SERVICE LETTER 242

Cessna 206H Soloy Hydraulic Pump Replacement Near Firewall on 3450A Floats

Textron Aviation (Cessna) 206 Hydraulic Pump Assembly p/n 1009225 has been discontinued. This service letter provides the option to replace it with pump p/n 1011945.

**DISCONTINUED OILDYNE
HYDRAULIC PUMP 1009225**

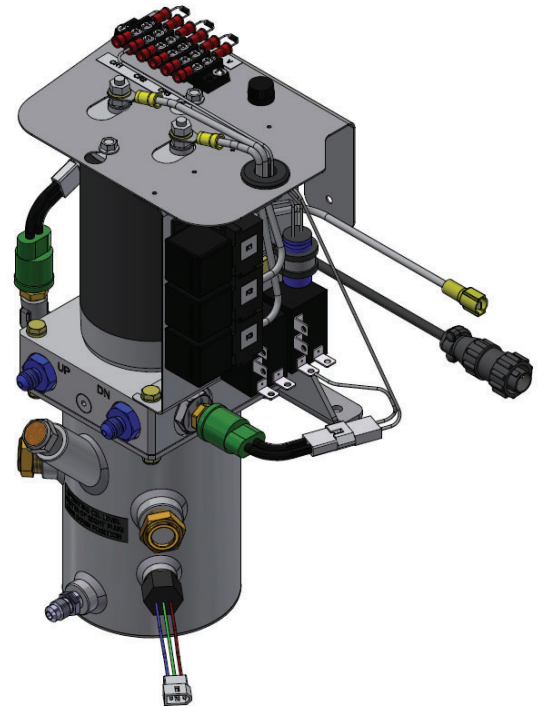
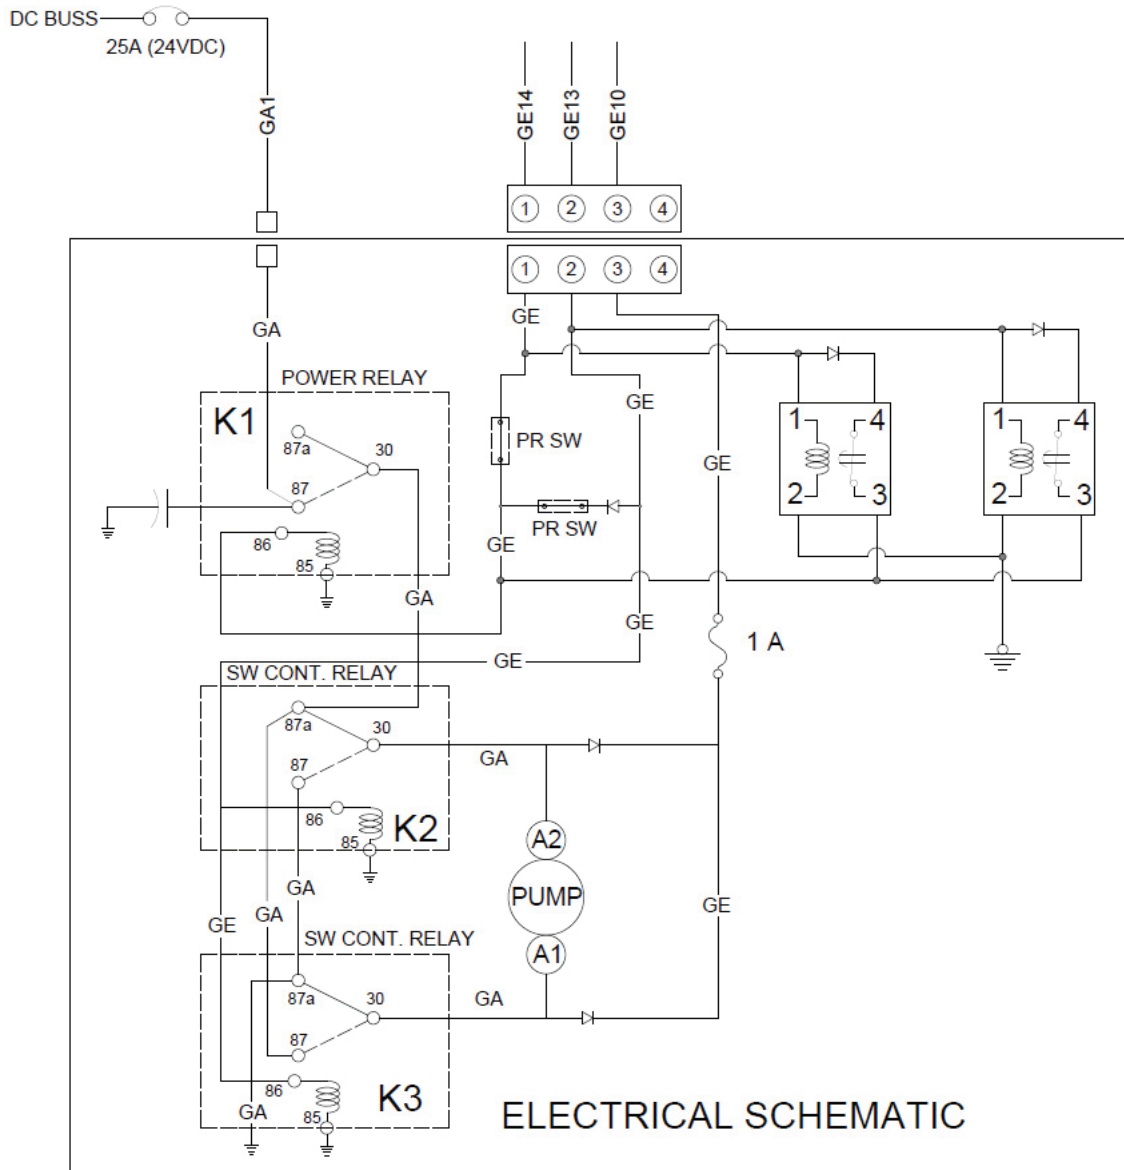
**NEW HYDRAULIC PUMP
1011945**

1. Disconnect aircraft battery.
2. Disconnect single pin Molex connector for GA1 wire from hydraulic power pack assembly.
3. Disconnect 4 pin CPC connector from hydraulic power pack assembly.
4. If aircraft has a hydraulic low level warning system, disconnect wire harness from sensor in reservoir.
5. Drain hydraulic fluid from hydraulic power pack reservoir.
6. Remove 1009301 hydraulic line from reservoir fitting to firewall. Note firewall fitting location.
7. Disconnect and cap 1009303 hydraulic line from pump “up” port.
8. Remove 1009302 hydraulic line from pump “dn” port to firewall. Note firewall fitting location.
9. Unbolt and remove hydraulic power pack from firewall and firewall angle.
10. Install new hydraulic power pack onto firewall angle using supplied hardware. Use existing hardware to attach the upper bracket to the firewall.

11. Re-install hydraulic line 1009303 onto pump “up” port.
12. Install new hydraulic line 1009302 onto pump “dn” port to firewall.
13. Install new hydraulic line 1009301 onto reservoir fitting to firewall.
14. If aircraft has a hydraulic low level warning system, reconnect wire harness to sensor in new reservoir.
15. Re-install 4 pin CPC connector. See electrical schematic.
16. Cut single pin Molex connector from GA1 wire. Install 73F-250-32-NL connector onto GA1 wire. Connect GA1 wire to power wire on hydraulic pump assembly. Run ground wire from hydraulic pump to ground on aircraft. See electrical schematic.
17. Reconnect aircraft battery, service pump reservoir with MIL-H-5606 hydraulic fluid and perform a retraction/extension test to make sure system is functioning correctly. Watch the system for leaks and add MIL-H-5606 hydraulic fluid as needed.
